Autoclass reference time v111

Figure 145–26—Single-signature PD Autoclass state diagram

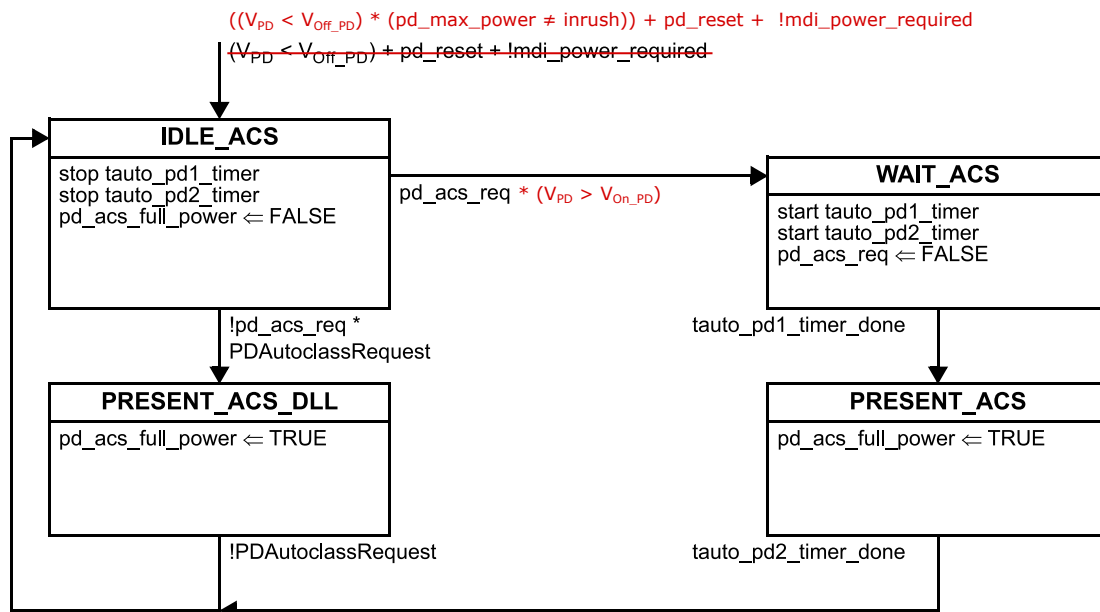
In addition, the PD Autoclass state diagram does not correctly handle PDs that collapse the voltage back down during inrush. If the voltage goes below $V_{\text{On_PD}}$, the entry arc into IDLE_ACS becomes TRUE, causing the state diagram to reset. To prevent this, we condition the entry arc with $\text{pd_max_power} \neq \text{inrush}$.

Change Figure 145–26 as follows:
